Company: ZHEJIANG EBOY TECHNOLOGY CO., LTD.

DECLARATION

We, **ZHEJIANG EBOY TECHNOLOGY CO., LTD.** hereby declare that product name:
LED LAMP (model name: EBE-BBW402, EBE-BBW403, EBE-BBW403-A, BW906, BW406,
BW306, BW206, C-BW906, C-BW406, C-BW306, C-BW206. FCC ID: 2AJ3WEBEBBW402).
EBE-BBW402 and EBE-BBW403 have been tested by BACL.

model: EBE-BBW403-A

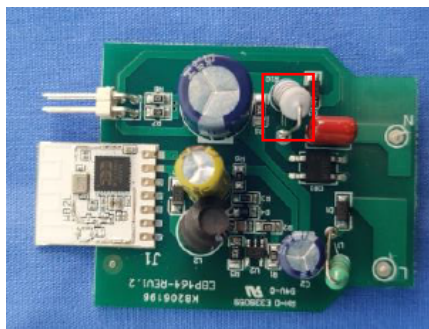
1. The difference between EBE-BBW402 and BW906, BW406, BW306, BW206 is only model name.
2. The difference between EBE-BBW403 and EBE-BBW403-A is the number of lamp beads and model name.

model: EBE-BBW402

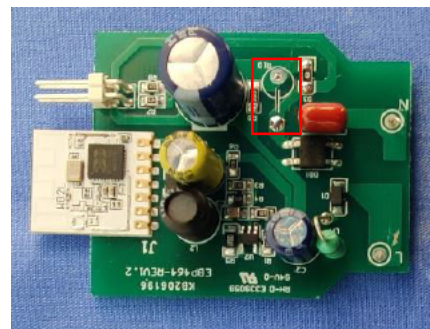
3. The difference between EBE-BBW403 and C-BW906, C-BW406, C-BW306, C-BW206 is only model name.
4. The differences between EBE-BBW402 and EBE-BBW403 are model name and PCB board.
EBE-BBW402 has resistance, EBE-BBW403 doesn't have resistance.
